BETHEL ACADEMY SUBDIVISION

**ASSESSMENT OF CURRENT CONDITIONS AND
NEEDED IMPROVEMENTS FOR ACCEPTANCE
INTO STATE MAINTENANCE PROGRAM**

**Darryl Shifflett
Warrenton Residency
January 8, 2007**

TYPICAL SECTION

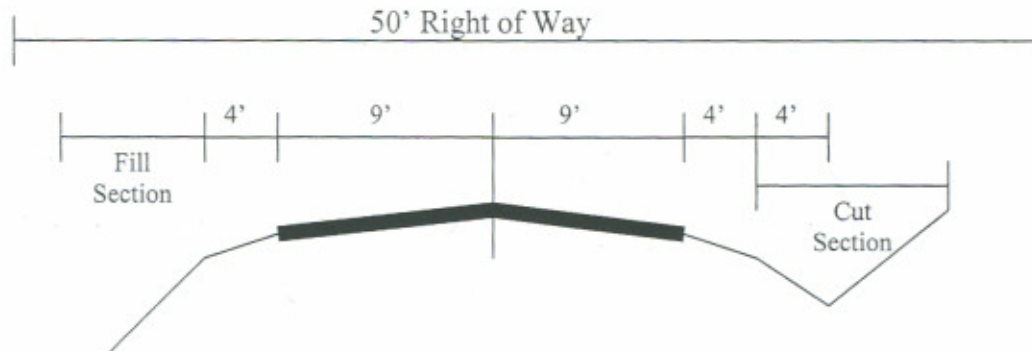
In accordance with the Department's 2005 Subdivision Street Design Guide (of the Road Design Manual – Appendix B), the minimum pavement width is 18-ft. (2 – nine foot travel lanes) with four (4) foot gravel shoulders and 3:1 front slope of ditch section for a width of four (4) feet (depth of ditch to be approximately 16" from back of shoulder to bottom of ditch). The back slope of the ditch section shall not be steeper than 2:1.

Travel lane slopes are to be $\frac{1}{4}'' : 1'$ and shoulder slopes are to be $\frac{5}{8}'' : 1'$ fall away from the centerline. The cut and fill sections are interchangeable based on the existing terrain.
